Re: Plan Modification – Filling Plan, Gas Extraction System Layout, and Beneficial Use Soils
Acceptance Criteria
Brown County South Landfill – License No. 3565

**Plan of Operation Modification Request of the
Filling Plan, Gas Extraction System Layout, and Beneficial Use Soils
Acceptance Criteria
Brown County South Landfill
WDNR Landfill License No. 3565**

LANDFILL GAS EXTRACTION SKID AND FLARE INSTALLATION

FIGURE 7 PHASE 4 TOP OF WASTE GRADES FILL SEQUENCE 4 - 1,092,000 CY

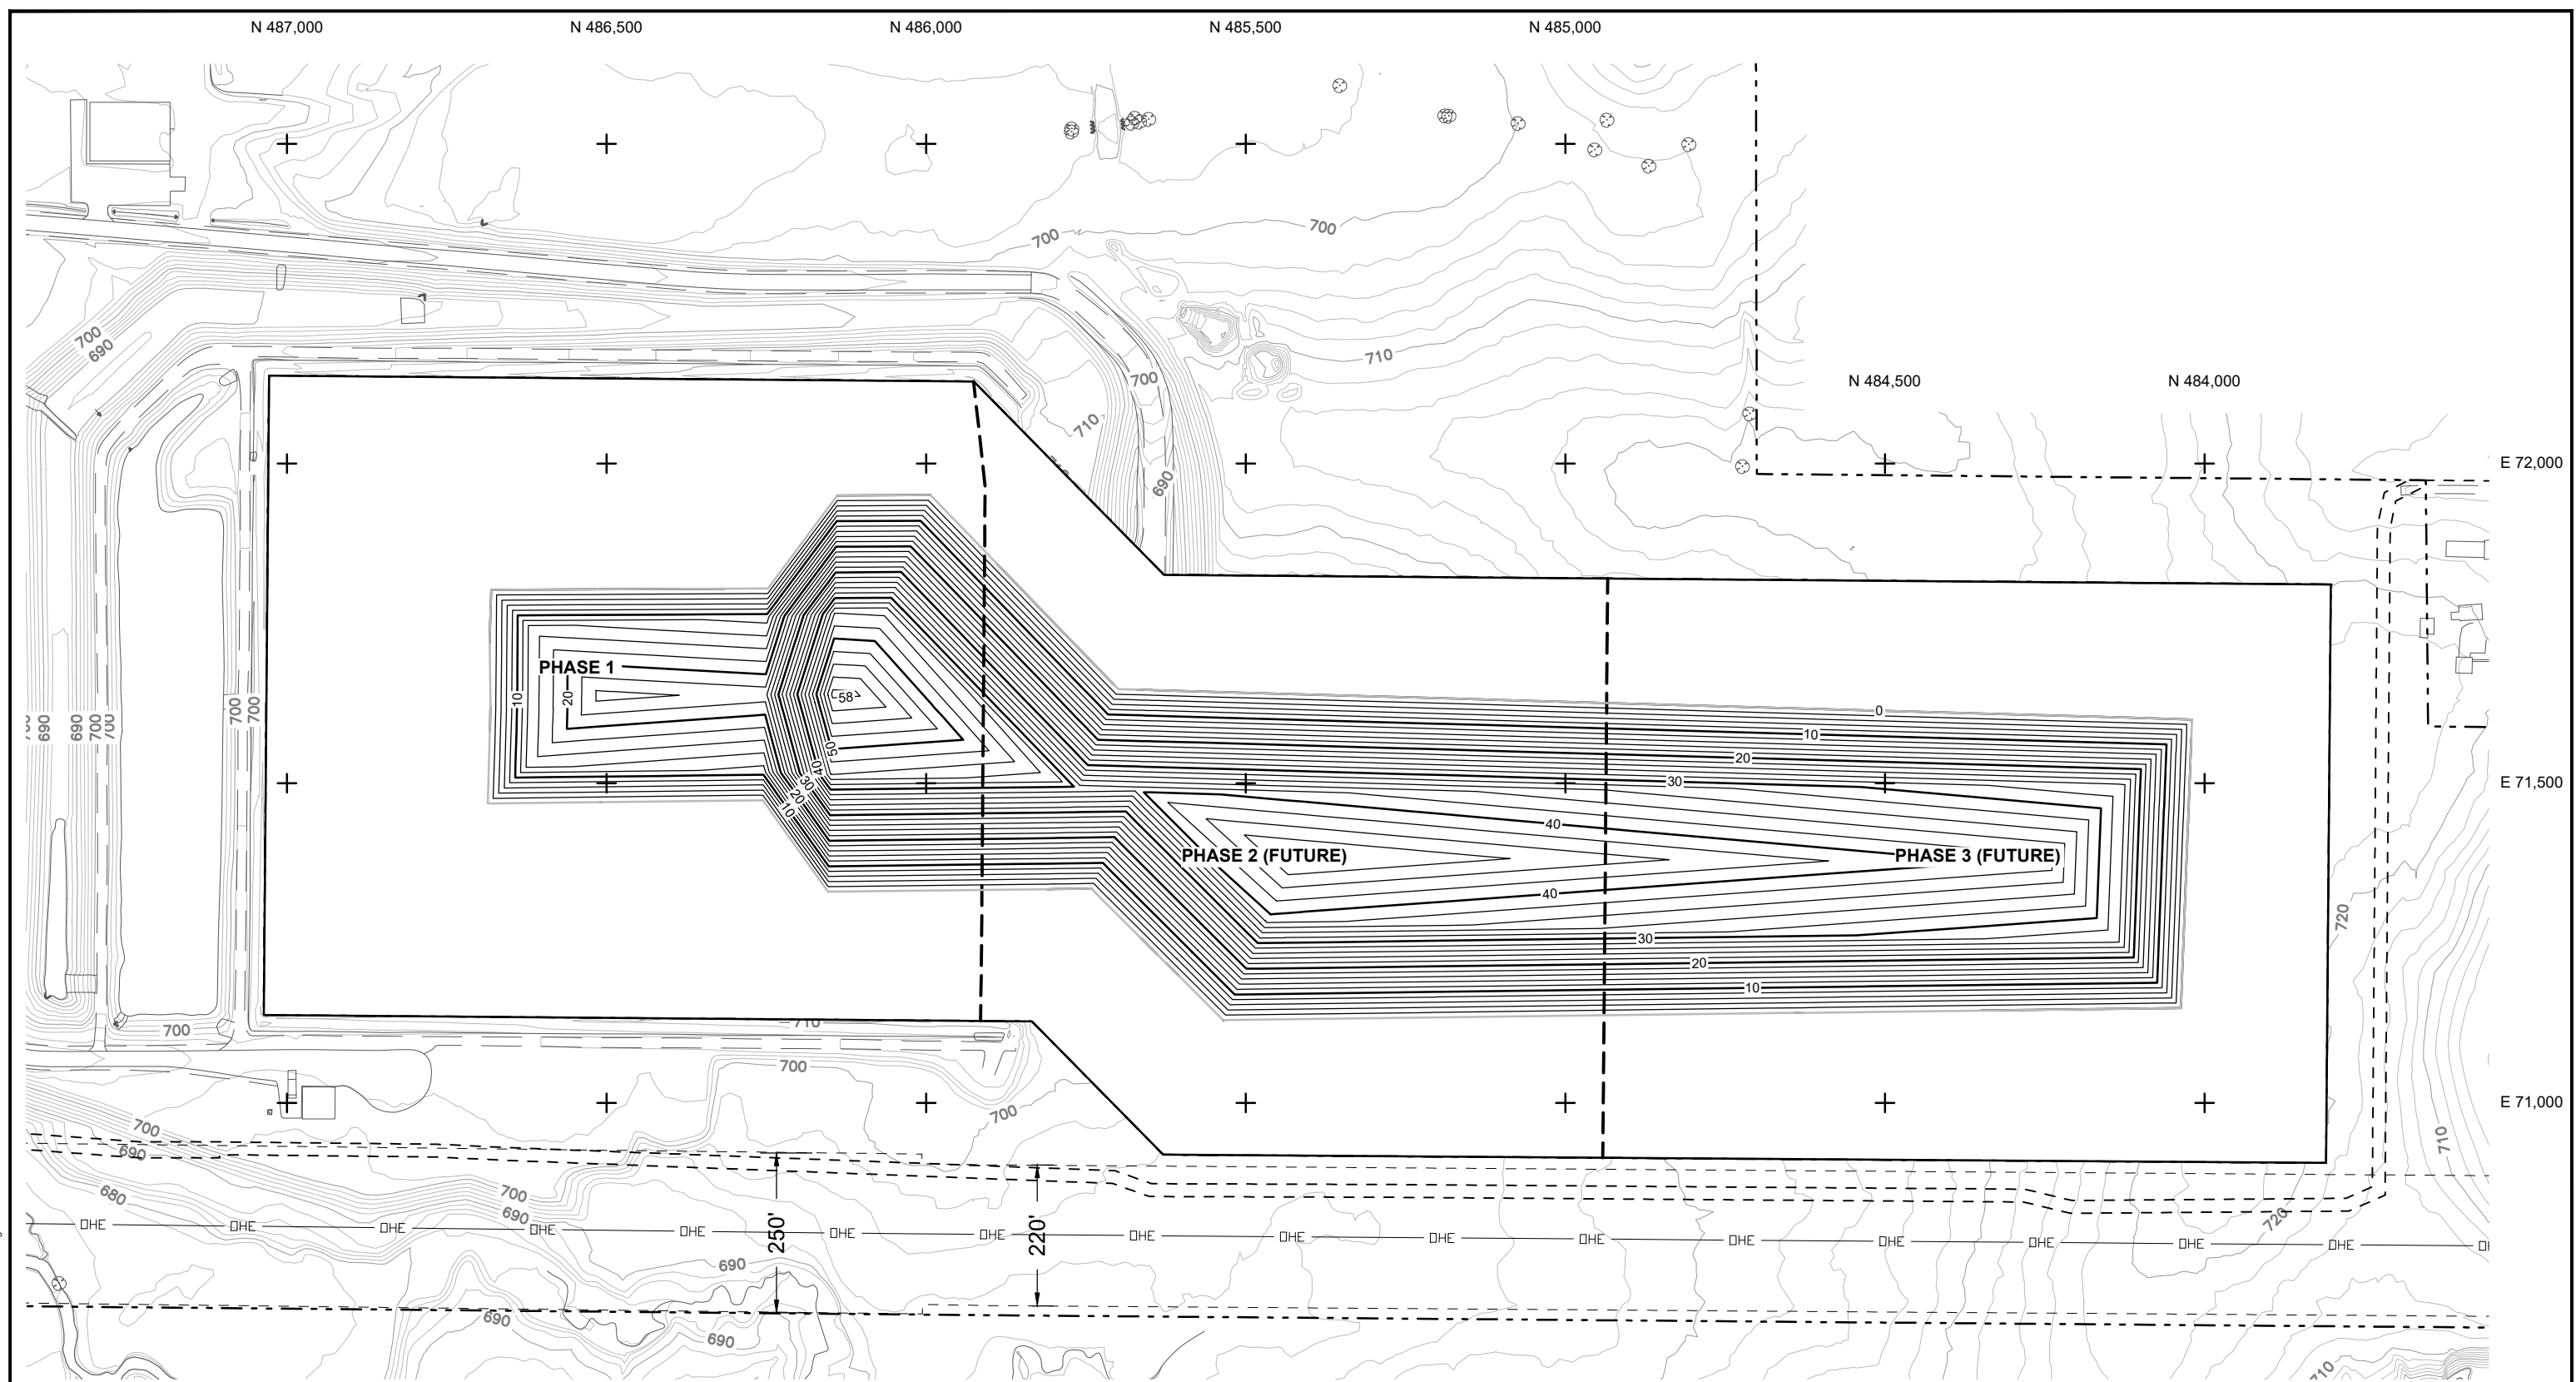
⁽⁵⁾ Phase 4 airspace is vertical filling in Phases 1-3 created by Phase 3 construction. Phase 4 Airspace Capacity reduced by 369,000 cubic yards (Phase 1A).
